SITE PLAN

REVIEW NOTES

17844 LESLIE STREET

2398804 Ontario Inc.

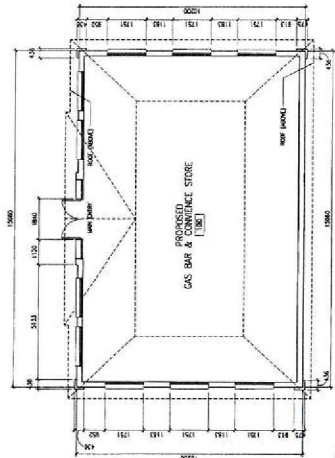
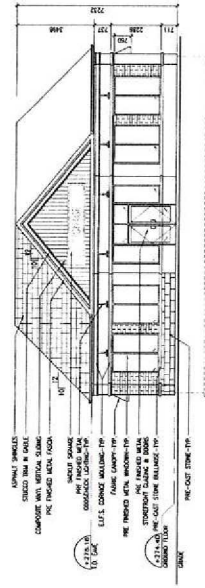
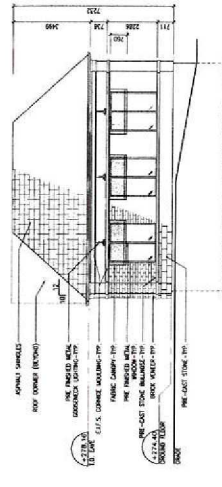
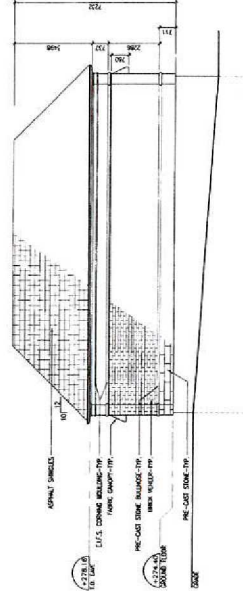
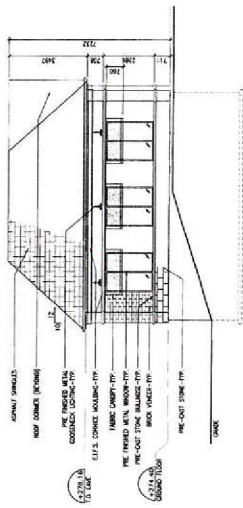
- Parking numbers and building setbacks appear satisfactory; spaces 3 and 4 may need to be relocated from area of underground fuel storage tanks
- Bicycle parking spaces are required in accordance with provisions of zoning by-law

- Tanker truck movements to be shown on Site Plan
- Details of garbage storage required; show location of enclosure on plans
- Snow storage areas to be shown on plans

- Zoning By-law requires provision of an opaque wooden fence 1.8 metres in height along westerly property line
- Daylighting triangle to be clearly shown on all plans

- Stormwater to be maintained on site; incorporate elements of low impact development into site
- Construction Management Plan (CMP) required prior to issuance of any building permit
